Ergänzung zur Betriebsanleitung

Auf Dauer technisch dichte Brenngasleitung

Addendum to Operating Instructions

Permanently technically tight fuel gas line

6.1 Gasflussschema (FIDOR ohne Katalysator)

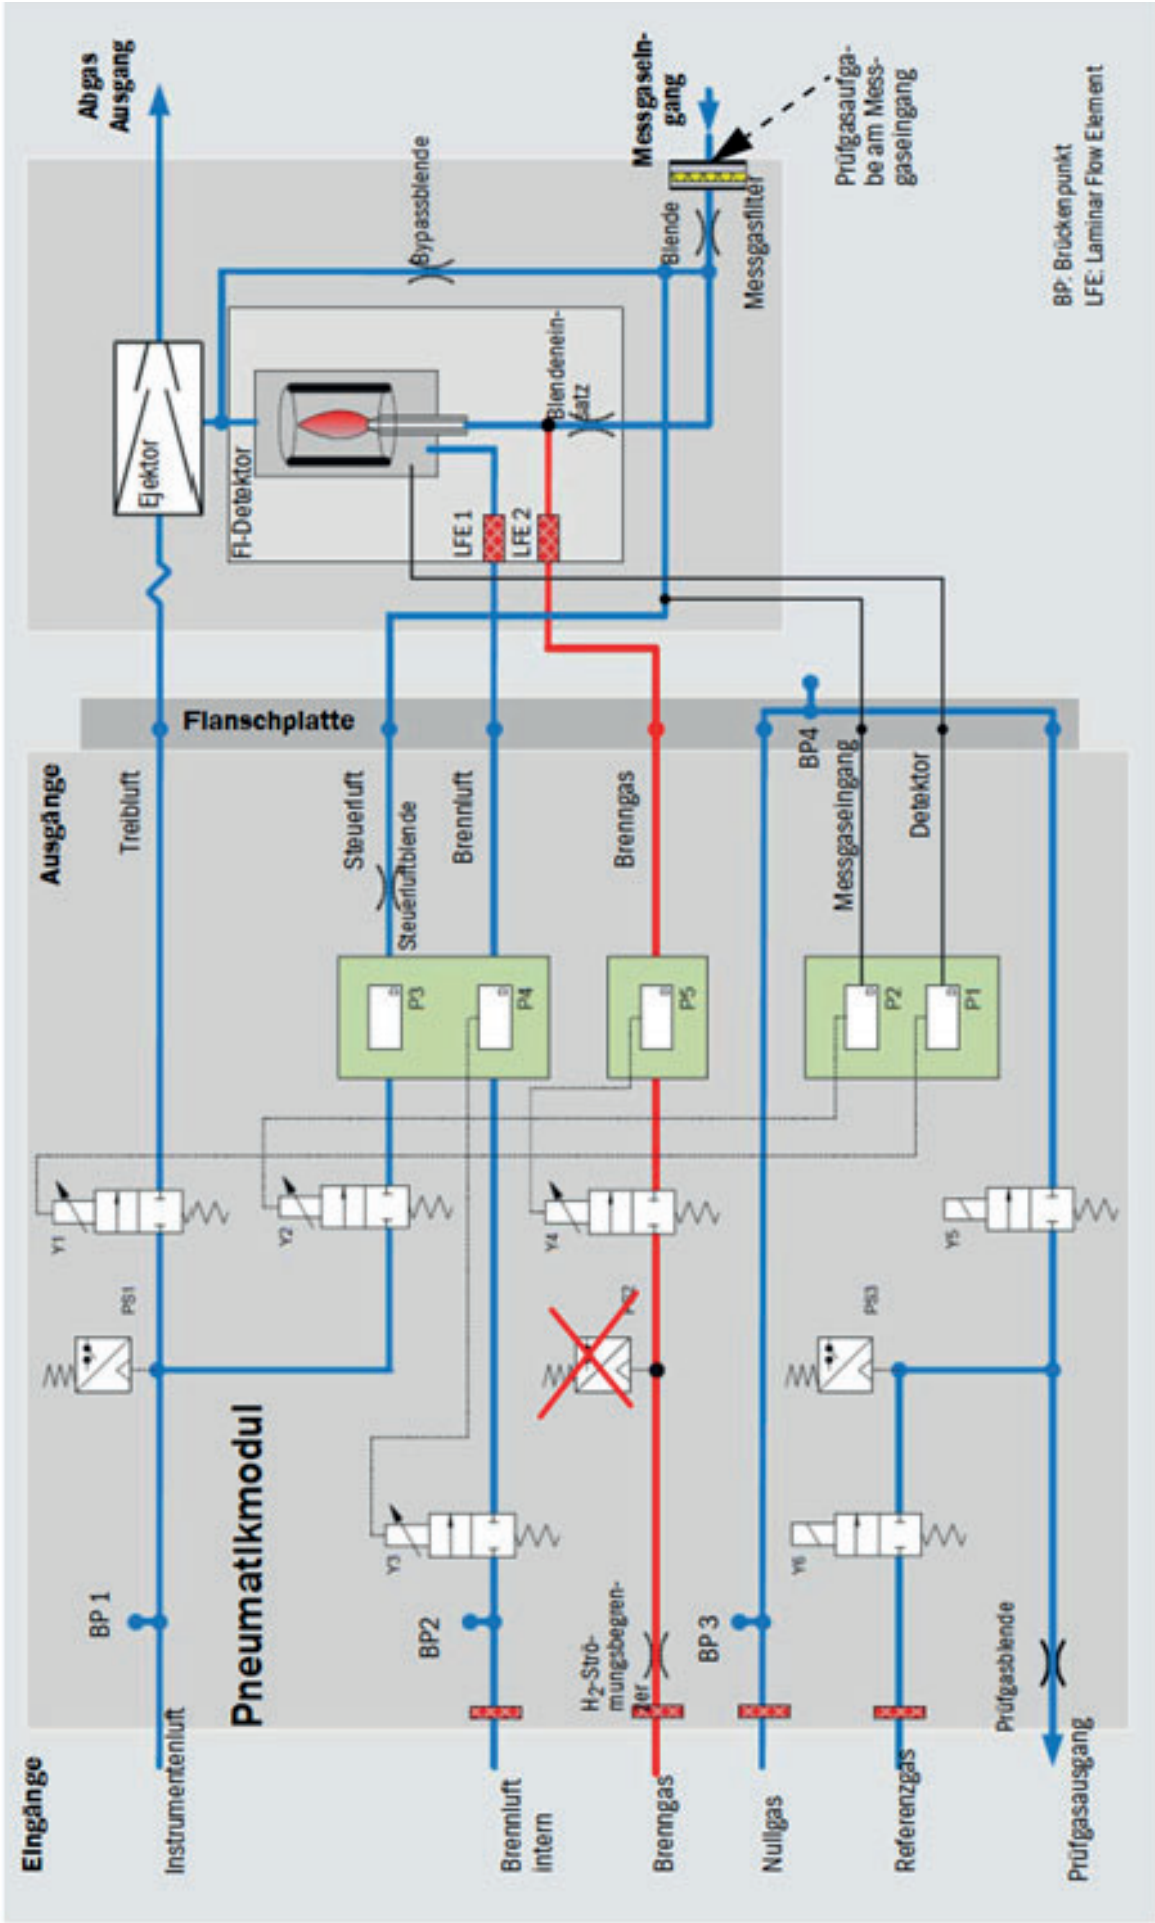
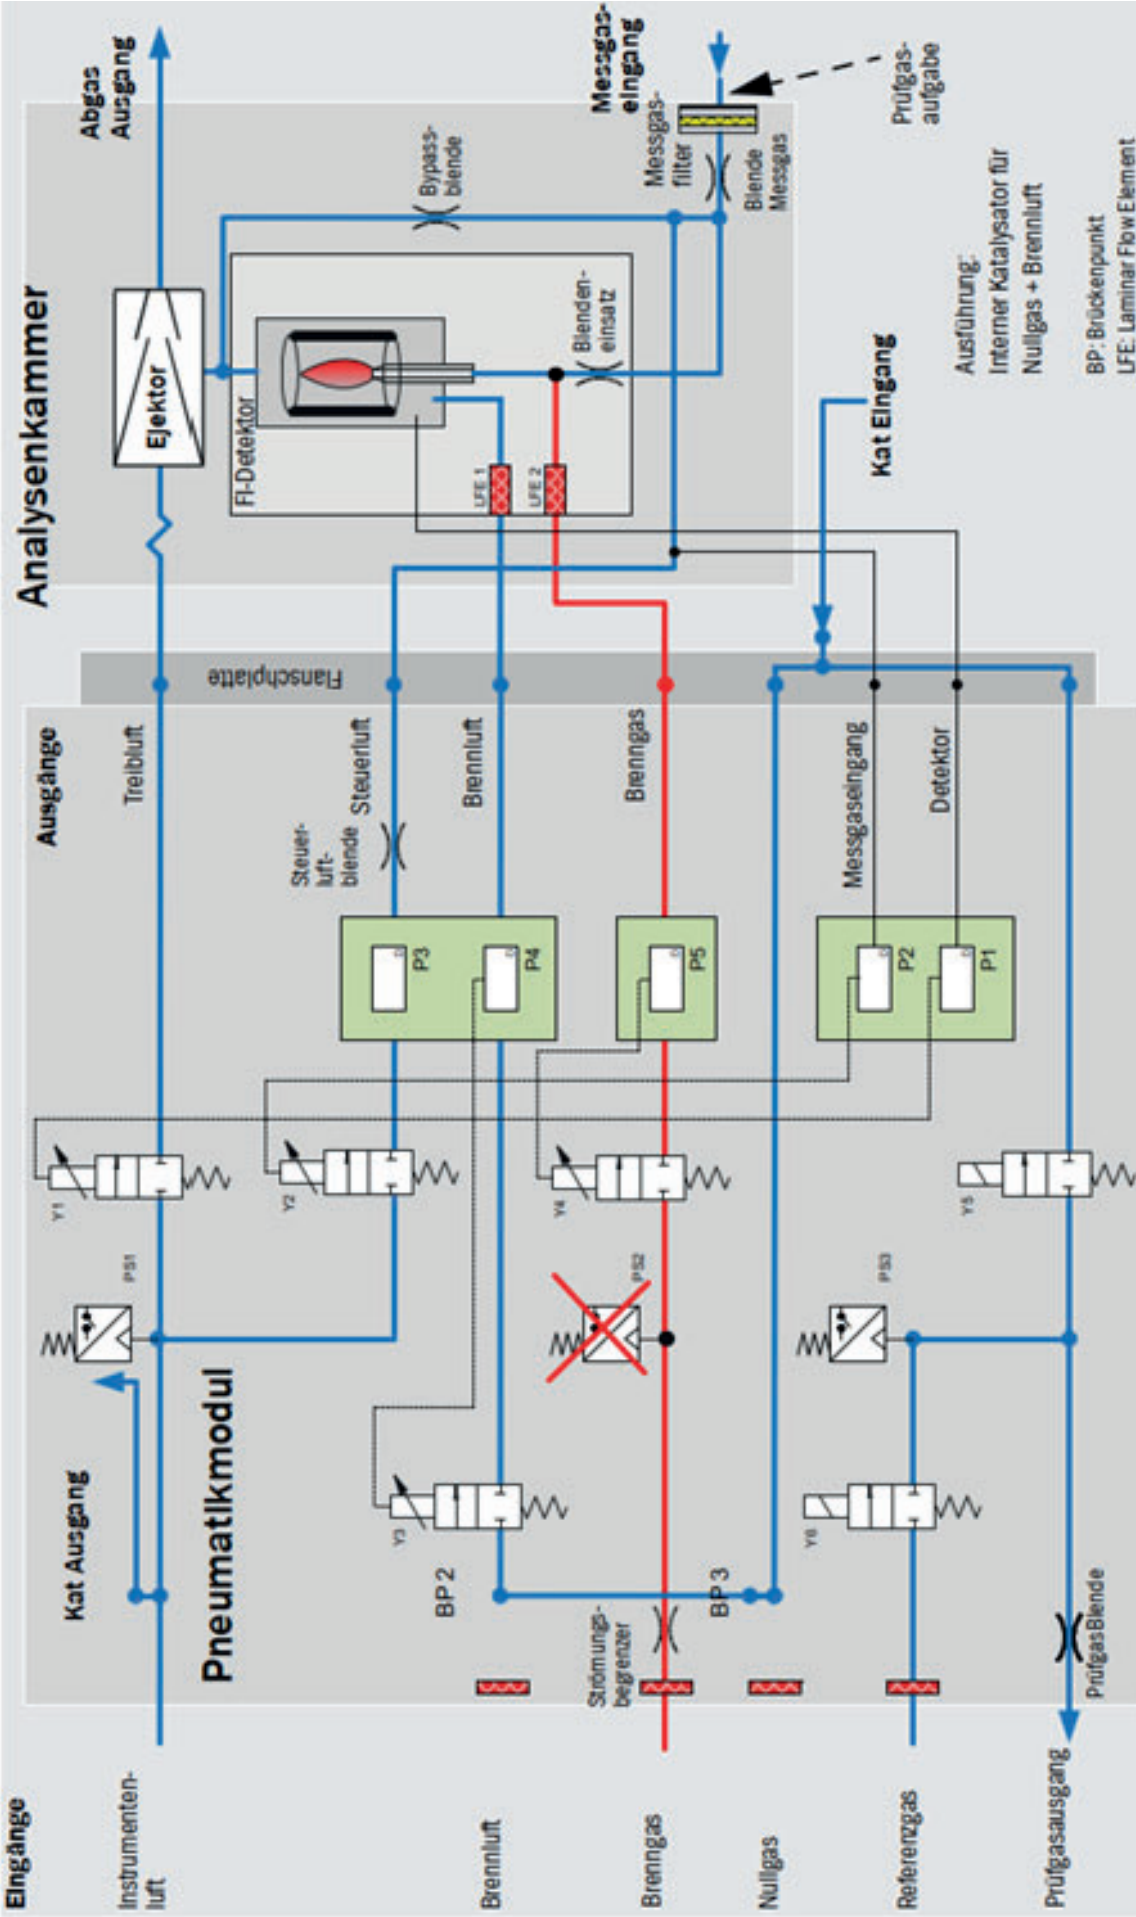
Im Folgenden sind die Abweichungen zur in der Betriebsanleitung abgebildeten Gasflussschemata kenntlich gemacht (Druckschalter PS2 entfällt).

The deviations from the gas flow diagrams shown in the Operating Instructions are shown below (pressure switch PS2 not applicable).
